SUBJECT:
Perry Nuclear Power Plant
Docket No. 50-440, License No. NPF-58
Mid-Cycle Revision to the Core Operating Limits Report for Operating Cycle 17

Enclosed is Revision 27 of the Core Operating Limits Report for the Perry Nuclear Power Plant (PNPP). This mid-cycle revision is submitted to the Nuclear Regulatory Commission (NRC) in accordance with PNPP Technical Specification 5.6.5, "Core Operating Limits Report (COLR)." A summary of the revision begins on page 25 of the COLR.

CORE OPERATING LIMITS REPORT FOR THE PERRY NUCLEAR POWER PLANT UNIT 1 CYCLE 17 (RELOAD 16)

Rev. 27 Middle of Cycle 17 Update – clarify Single Loop Limits and to provide Thermal Limits for when the Power Load Unbalance is Out Of Service:

Figure 3.2.2-1
Flow Dependent MCPR Limit (MCPR_f)
Fuel Type: GE14 / GNF2

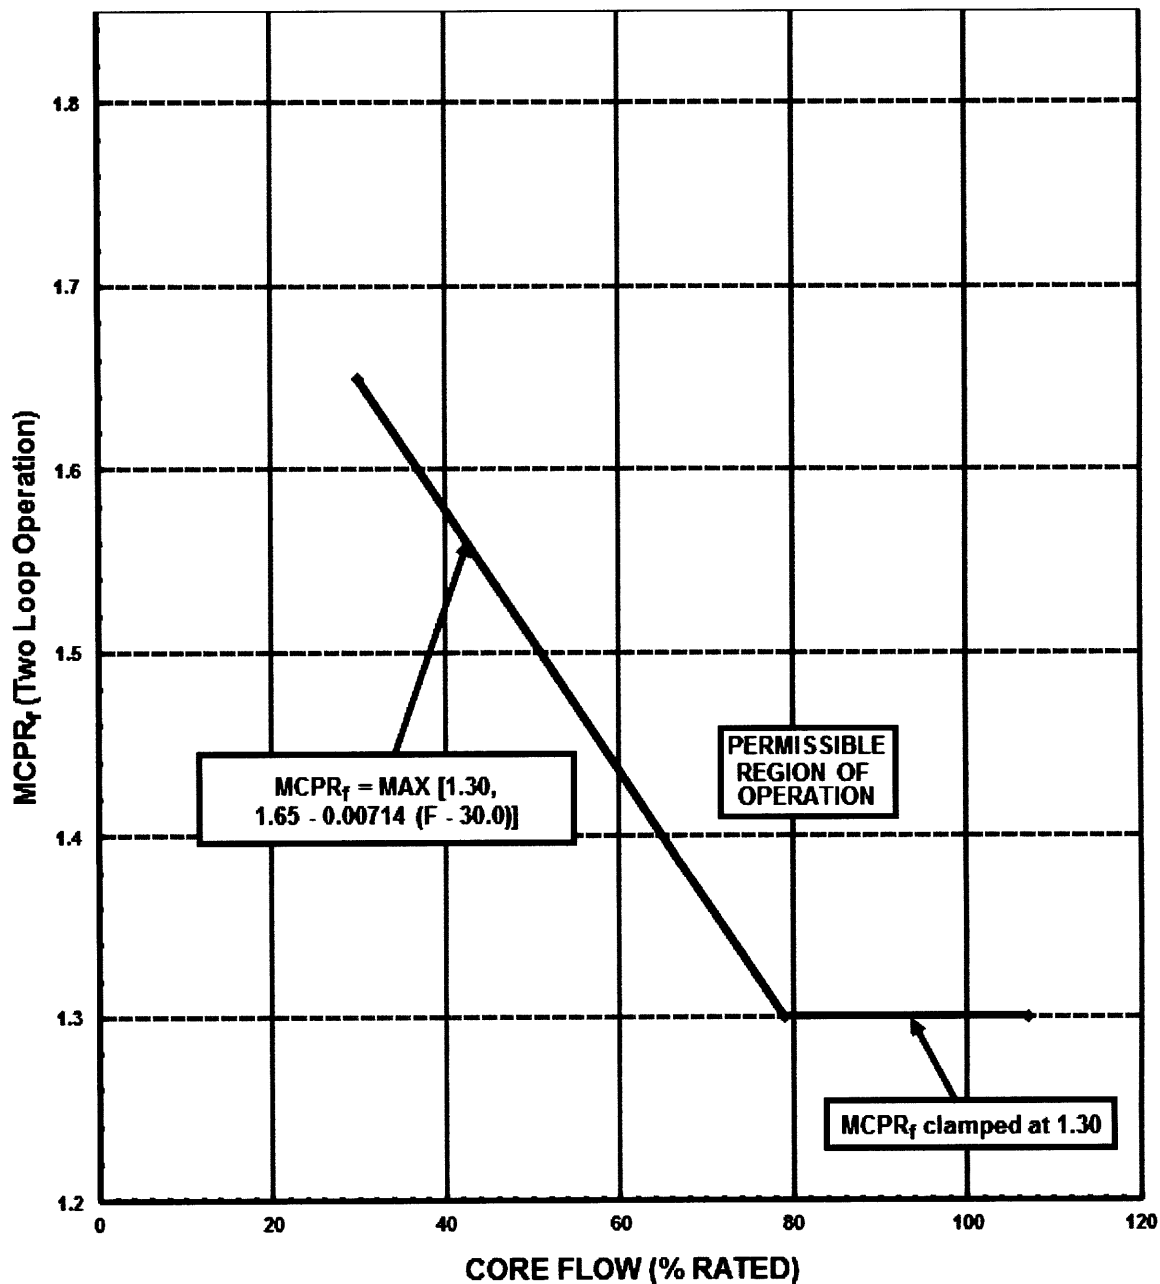
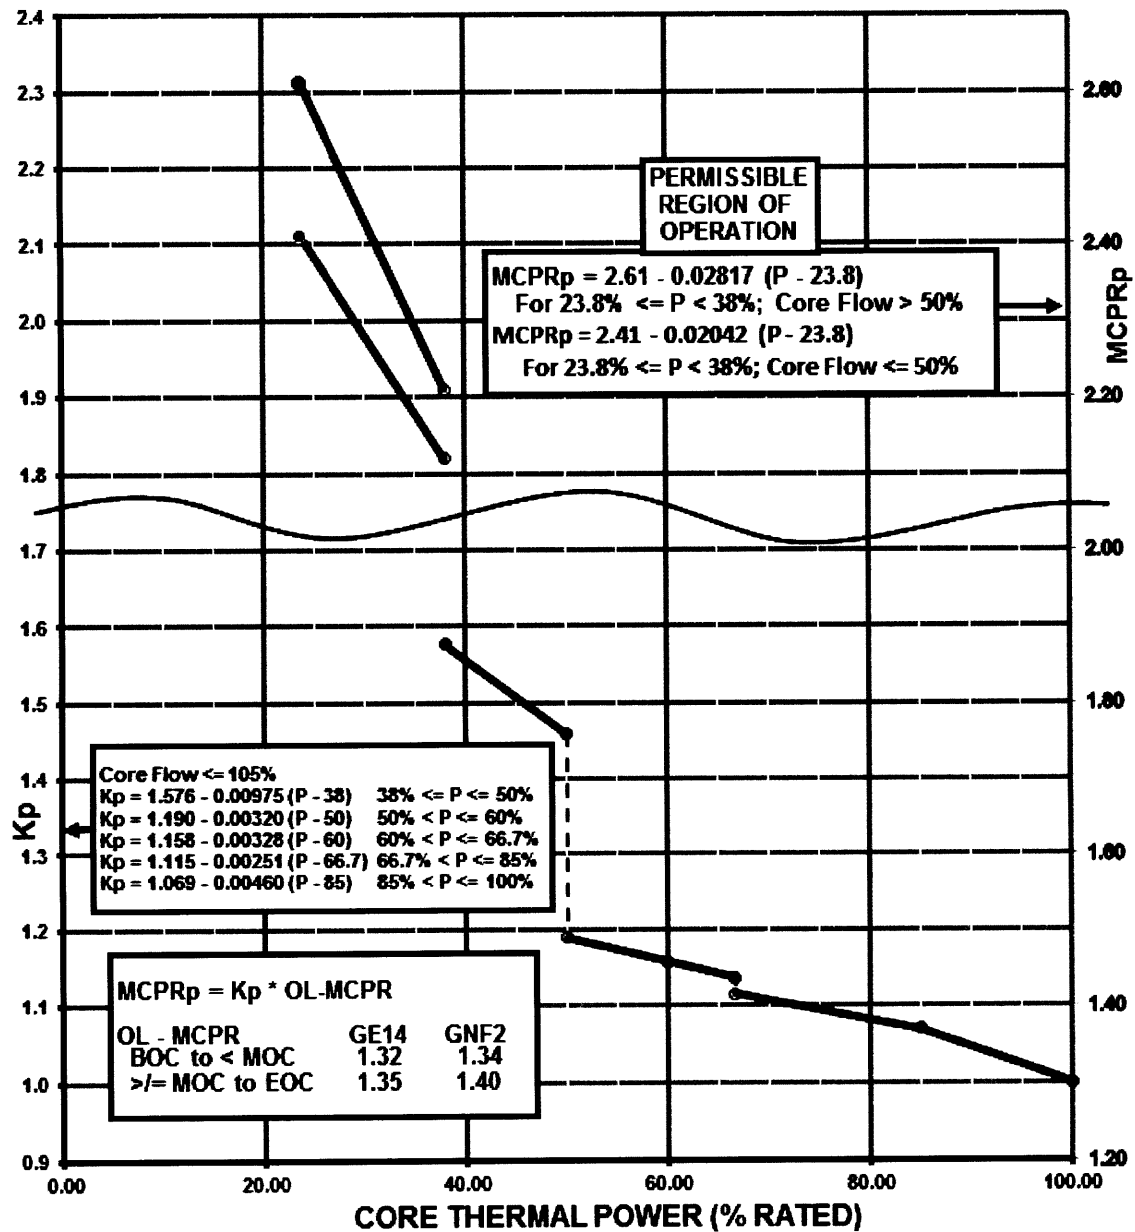
- e. Renumbered and updated figure titles as appropriate – Rev bars not included.
 - f. Figures 3.2.2-1 and 3.2.2-2, removed from “Two Loop Operation” from the title – Rev bars not included.

Figure 3.2.2-3
Power Dependent MCPR Limit (MCPR_p)
Pressure Regulator Out Of Service
Power Load Unbalance Out Of Service
Fuel Type: GE14 / GNF2

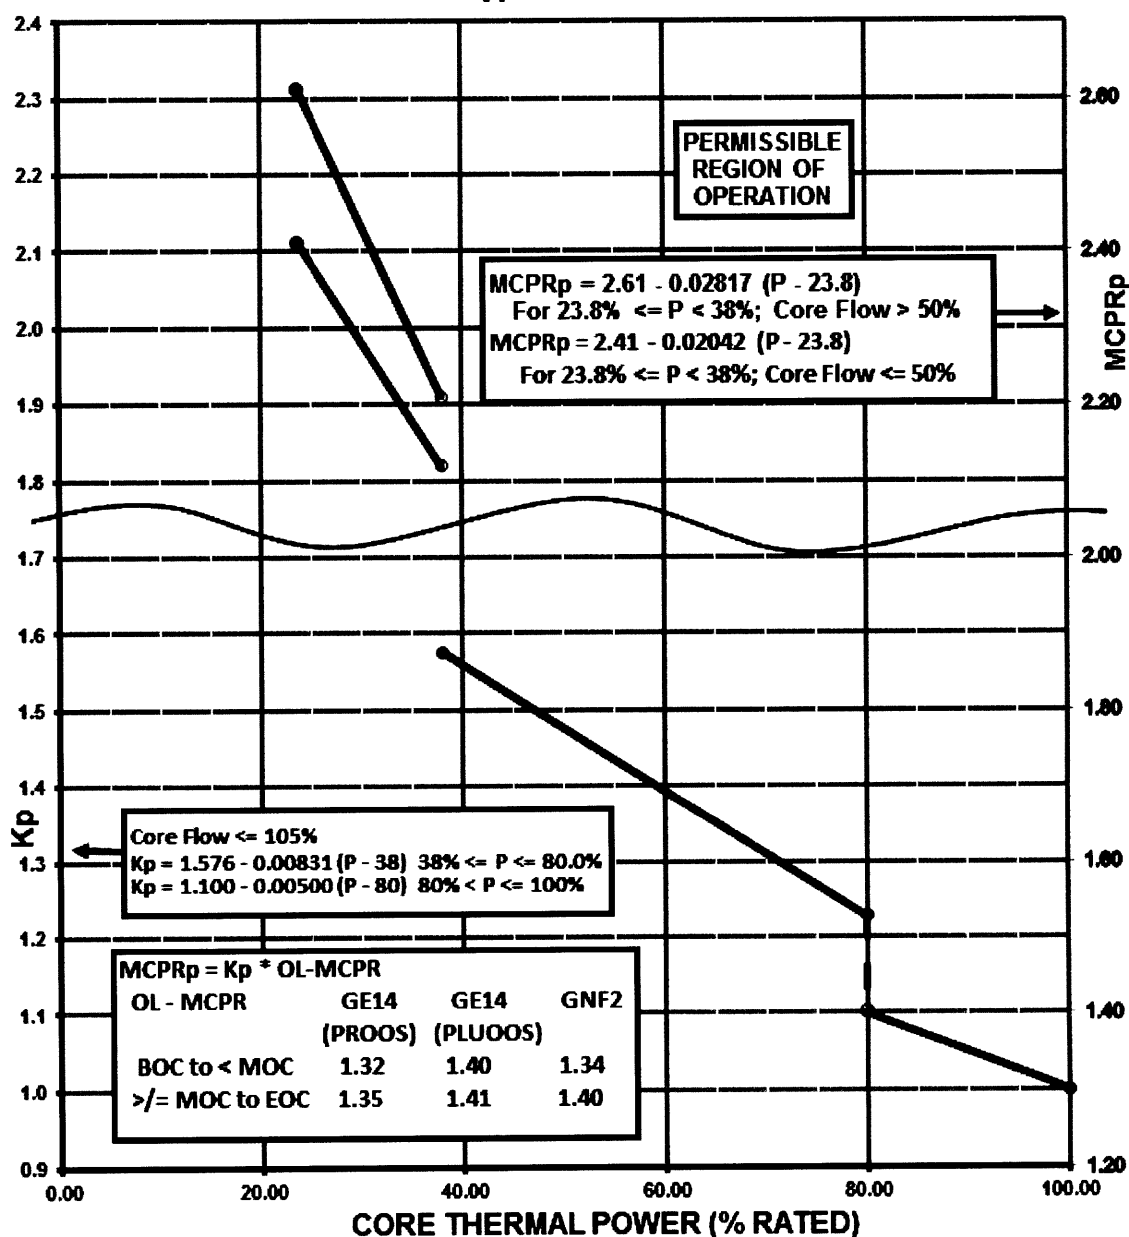
- b. Section 4, updated the Operating Limit MCPR for GE14 with PLUOOS.
 - c. Section 4, identified that PROOS Limits are to be used with PLUOOS.
 - d. Figure 3.2.2-3, added “PLUOOS” to the title and updated the OL-MCPR for GE14 (PLUOOS).

Figure 3.2.3-2
Power Dependent LHGR Factor (LHGRFAC_p)
Equipment In Service
Pressure Regulator Out Of Service
Fuel Type: GE14 / GNF2

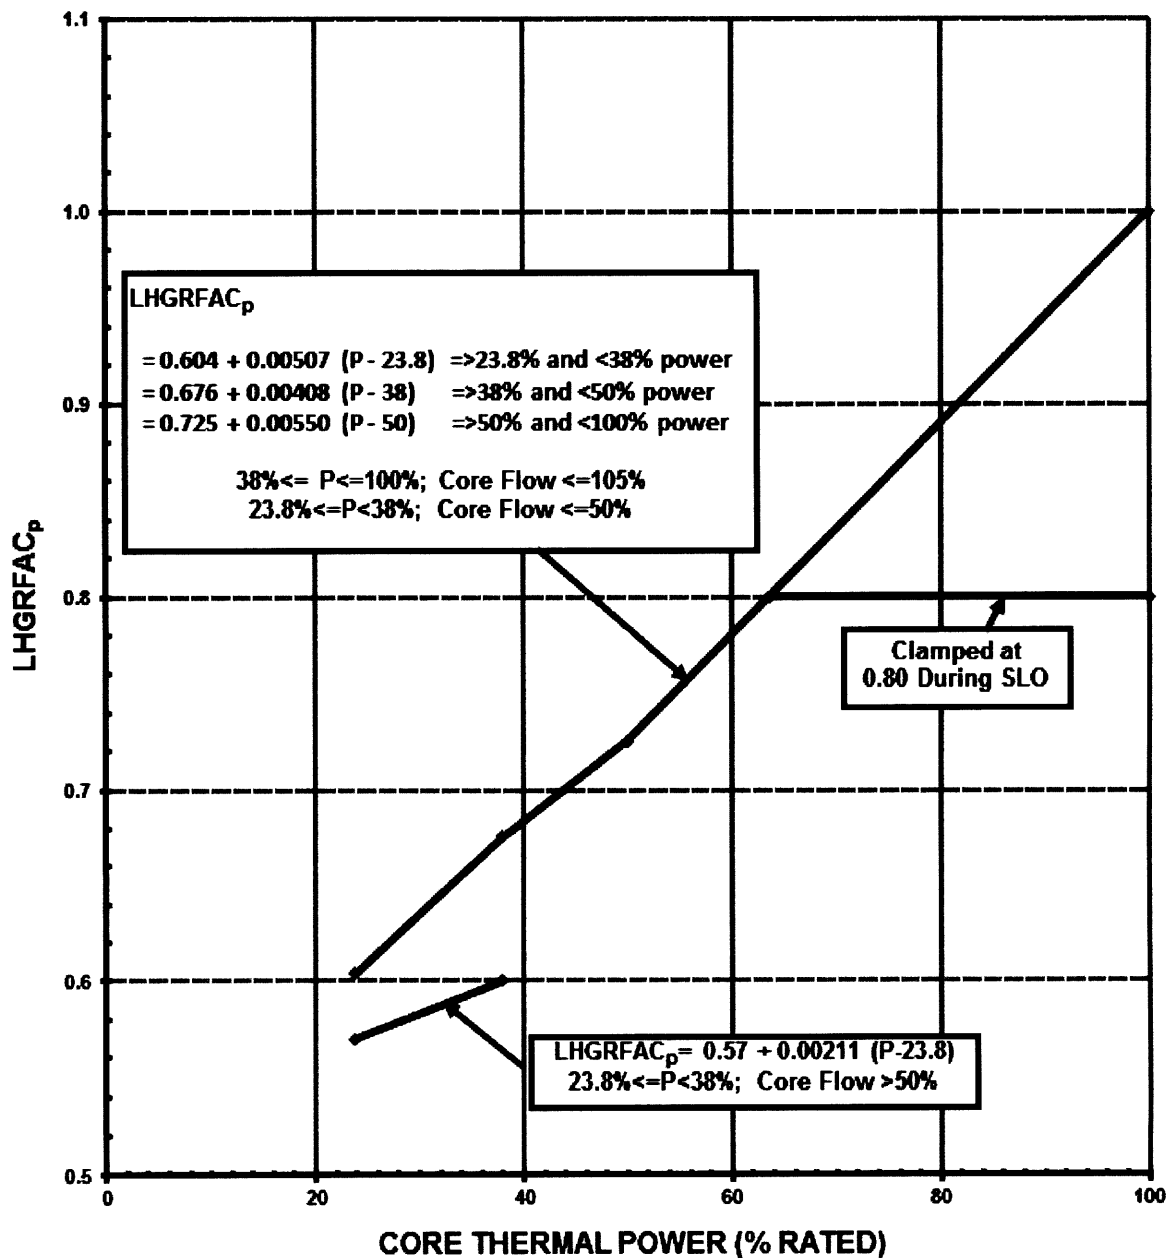
- e. Section 5, added discussion that LHGRFAC_p is dependent on the flexibility option selected – LHGRFAC_p (EIS/PROOS) and LHGRFAC_p (PLUOOS).
 - f. Figure 3.2.3-2, added “EIS and PROOS” to the title.

Figure 3.2.3-3
Power Dependent LHGR Factor (LHGRFAC_p)
Power Load Unbalance Out Of Service
Fuel Type: GE14 / GNF2

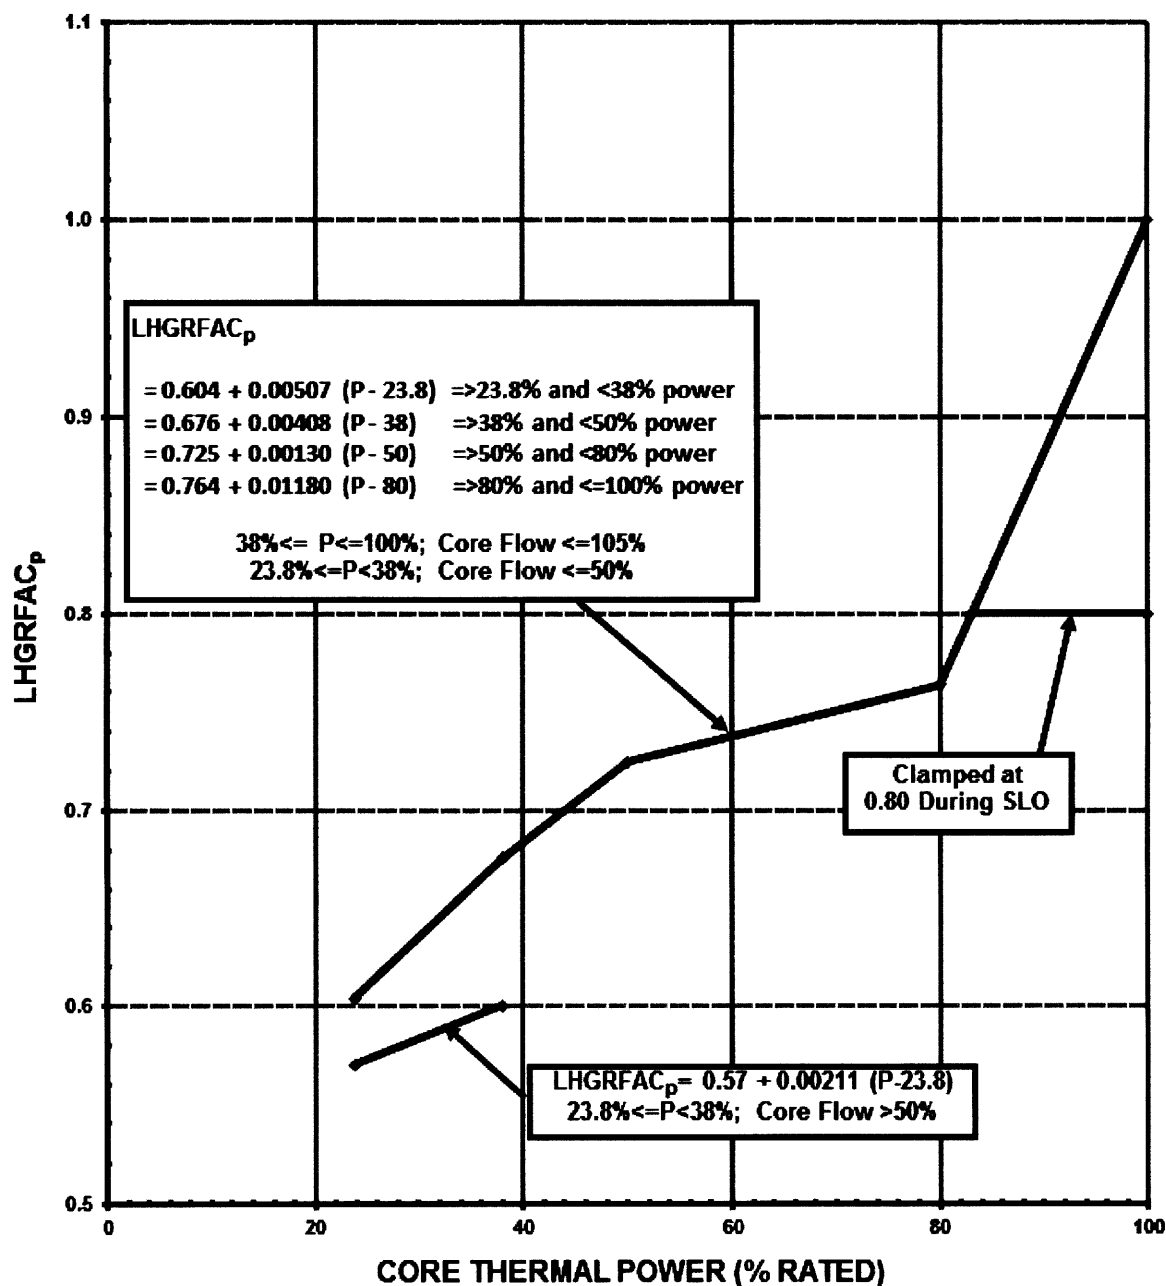
- g. Added Figure 3.2.3-3 LHGRFAC_p (GE14 / GNF2 PLUOOS).
